Staff Report

Raleigh Appearance Commission Administrative Alternate Request

Case File / Name: AAD-11-21 – 7100 Falls of Neuse Road

Request: The applicant requests an administrative alternate for UDO Section 1.5.6. Build-to.

BUILT TO EXHIBIT

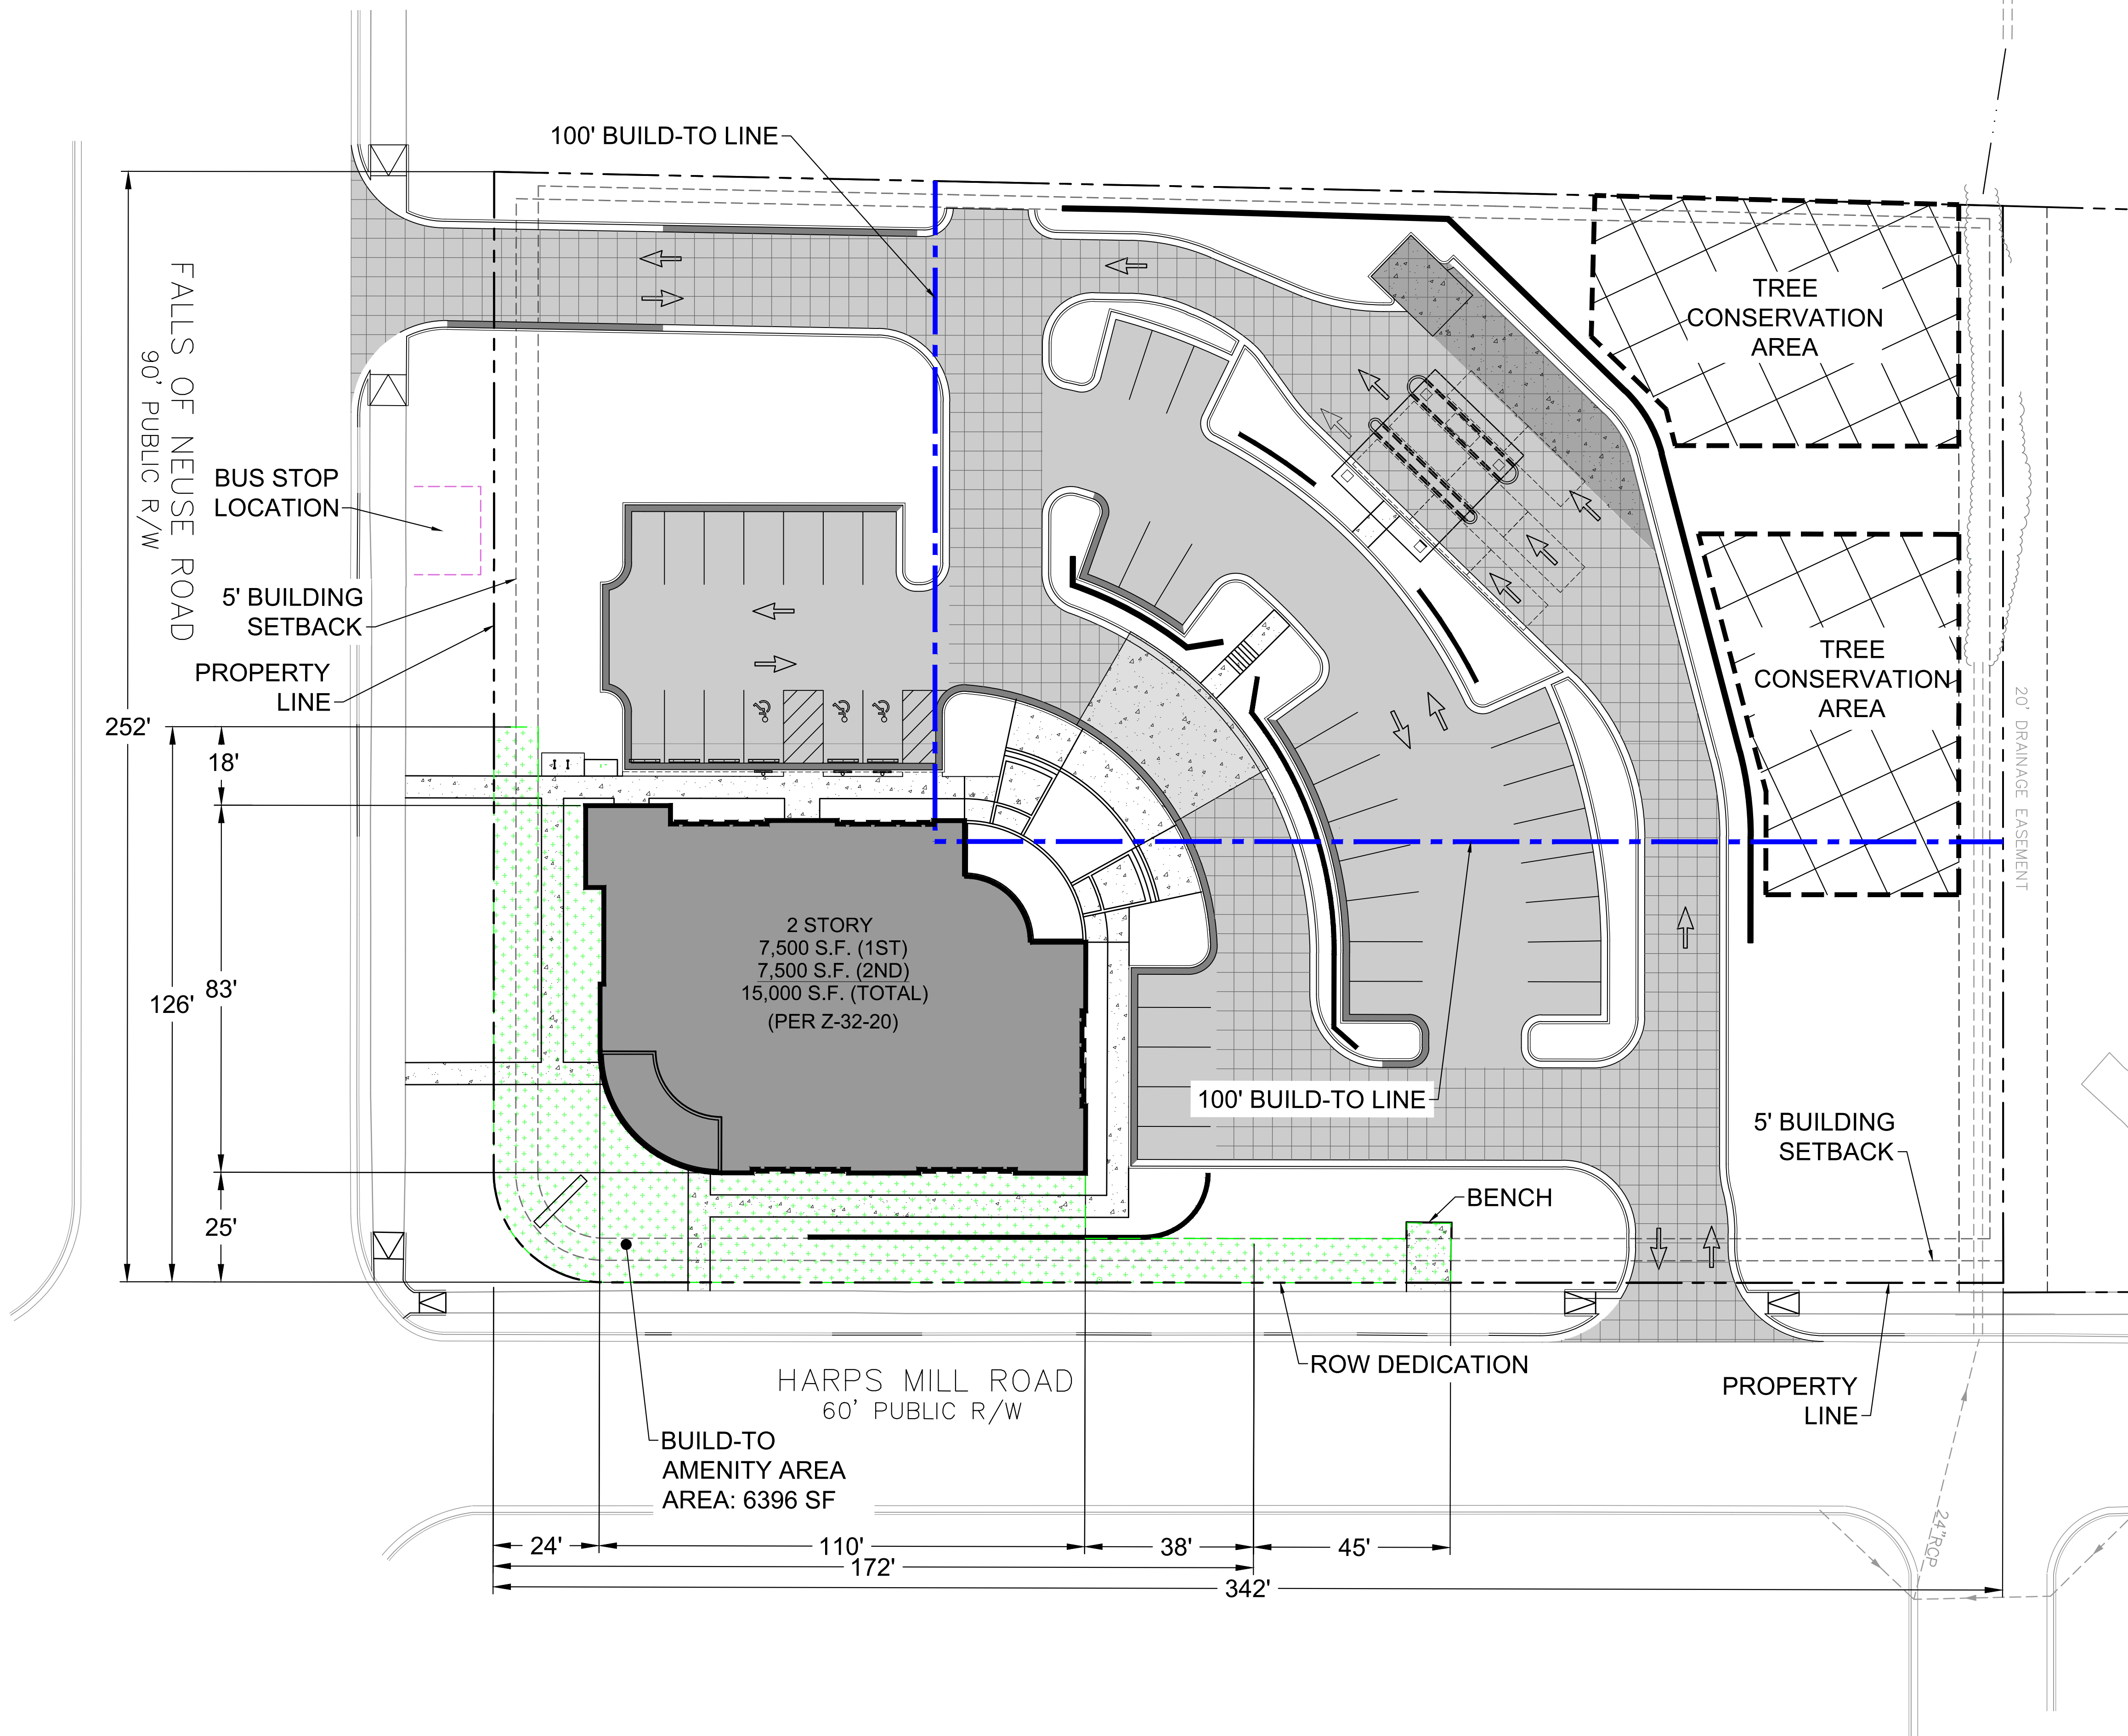
The proposed building meets the corner requirement and is placed within the build-to on both streets, but only occupies 33% of the lot width on Falls of Neuse Road and 32% on Harps Mill Road. As an alternate design, the applicant proposes open amenity areas along each block face at lengths sufficient to meet the coverage width requirement when combined with building length.

Response: As shown on the attached Exhibit, those areas that would have otherwise been occupied by buildings will be converted to outdoor amenity area.
